Interactive comment on “Subglacial permafrost dynamics and erosion inside subglacial channels driven by surface events in Svalbard” by Andreas Alexander et al.

Andreas Alexander et al.

Received and published: 30 July 2020

Fig. 1. Figure 4 from the manuscript with same scale for surface air and cave temperatures.

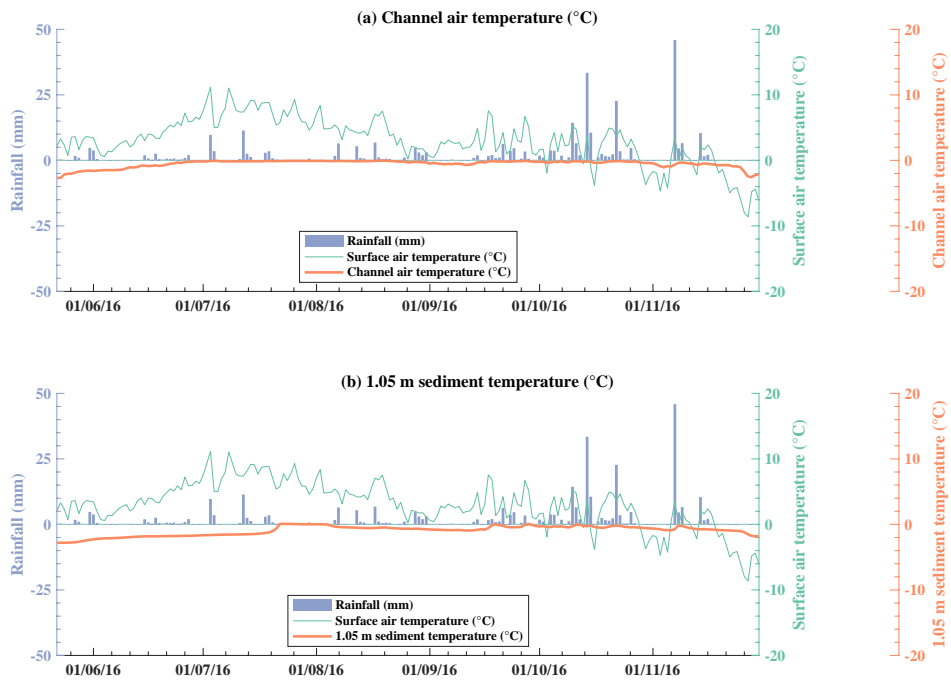
Page 9, Fig 4 – It would really help visualize relationships between outside air temperature and the cave/sediment temperatures if they were plotted at the same scale.

We produced such a figure, see the below figure (Fig. 1). As the cave temperatures appear at the scale of the outside temperatures almost as a straight line without much information given, we prefer to leave the temperatures in Fig 4 at different scales to allow for easier interpretation of the results.
